**Economic and Social Council**Distr.: General
19 July 2023

World Forum for Harmonization of Vehicle Regulations**Working Party on General Safety Provisions****126th session**

Awareness of the Proximity of Vulnerable Road Users:**UN Regulation No. 167 (Vulnerable Road Users Direct Vision)****Proposal for Supplement 1 to the original version of UN
Regulation No. 167 (Vulnerable Road Users Direct Vision)****Submitted by expert from the United Kingdom ***

"Figure 1

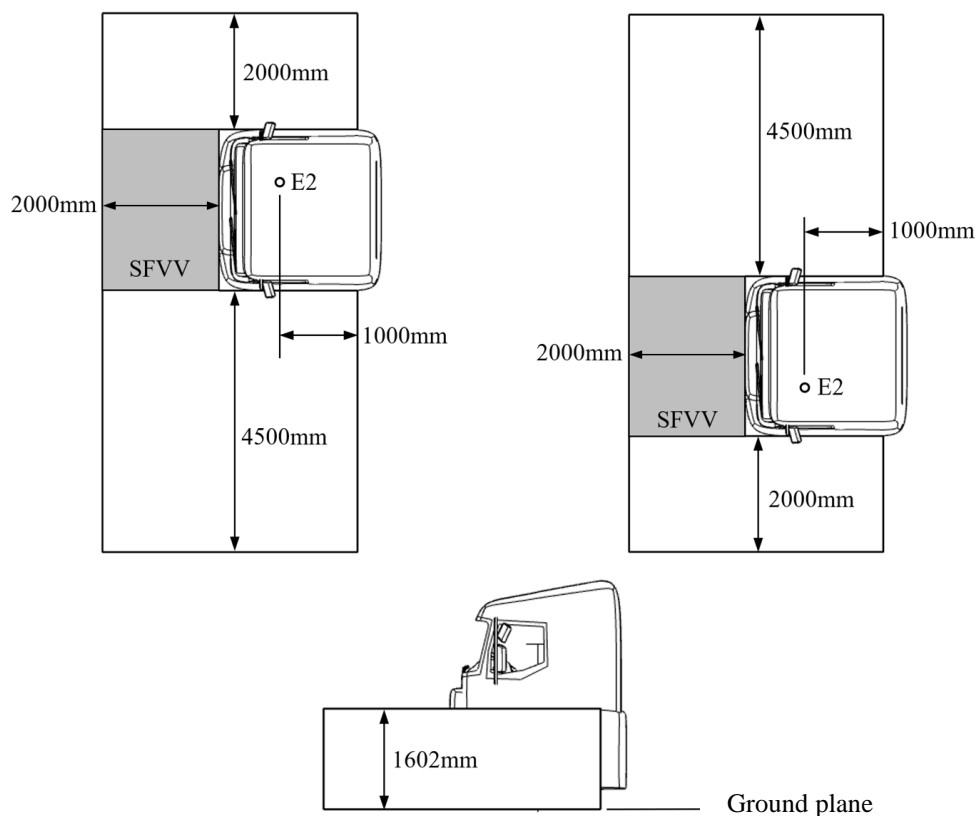
Figure 1, shall be deleted

Insert new Figure 1 which shows the SFVV, to read:

"2.9.4. Subsection Frontal Visible Volume (SFVV)" is defined as a portion of the assessment volume that includes the volume directly in front of the vehicle, between the offside and nearside planes."

Figure 1

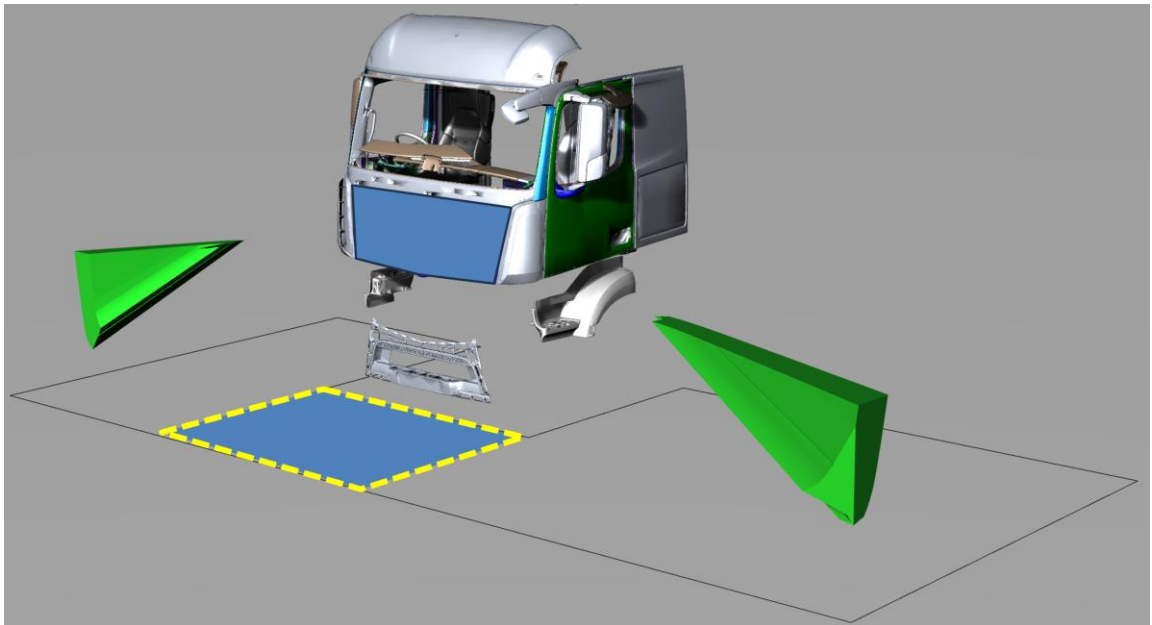
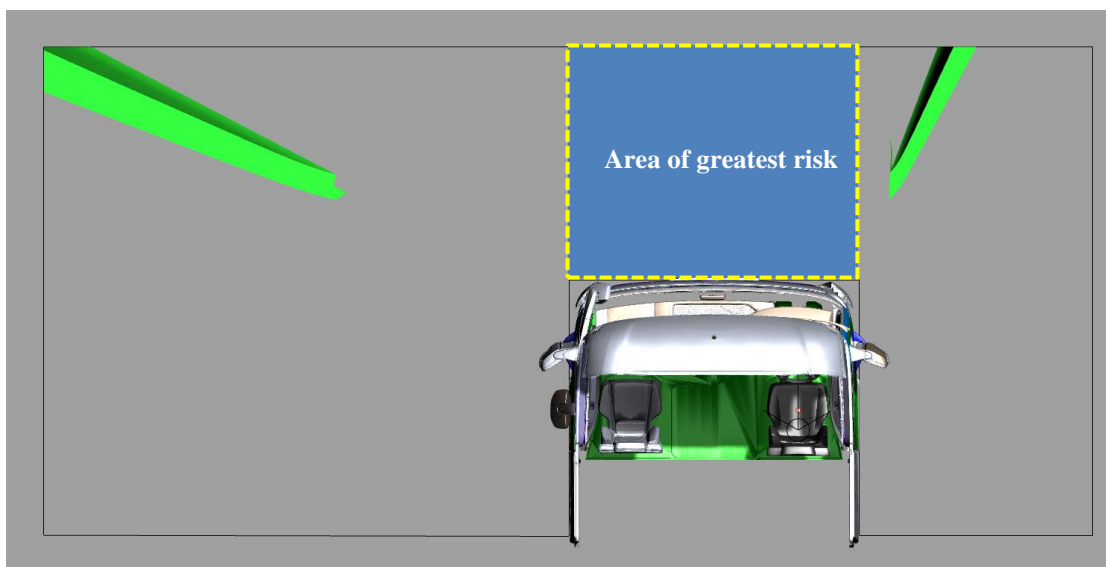
2. The analysis that led to this solution also highlighted an additional issue. By moving the A-pillars rearwards in the longitudinal axis with respect to the driver, frontal volume can be gained which is outside of the area of the greatest risk as shown in Figure 1 and Figure 2.

5. Therefore, the use of the strategy of moving the A-pillars rearwards by 100mm could allow 20 – 38 per cent of the required visible volume to the front of the vehicle for level 2/3 vehicles (1m^3) to be obtained. Figure 1 and Figure 2 show the location of the volume that can be gained for an example vehicle, after moving the A-pillars rearwards by 100mm in the longitudinal axis.

9. The example shown in Figures 1-3 highlights that moving the A-pillars rearwards allows volume to the front of the vehicle to be gained, in locations which do not improve the direct vision of the area of greatest risk as defined by the VRU placement in the work to define the required volumes and accident data analysis.

10. The proposed amendment defines a Subsection Frontal Visible Volume within the area of greatest risk with the aim of ensuring that VRUs directly in front of the vehicle cannot be in a blind spot between direct vision and indirect vision. This is currently possible with the series 00 version. The volumes that must be visible in the SFVV, and shown in table 1, have been derived by following the process stages below for levels 1, 2 and 3;

Figure 3

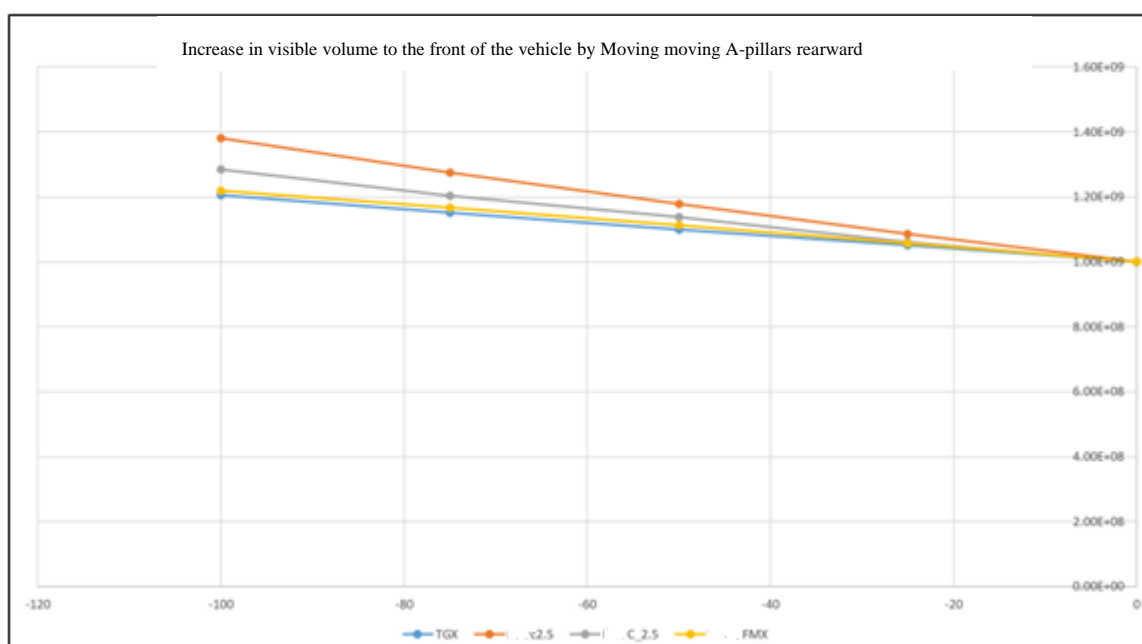
4. The graph shown in Figure 3 shows the volume that can be gained by moving the A-pillars rearwards in the longitudinal axis for the four test vehicles. Out of the four vehicles tested, the smallest improvement in volume gained through the rearwards movement by 100mm of the A-pillar is 0.2m^3 , and the largest is 0.38m^3 .
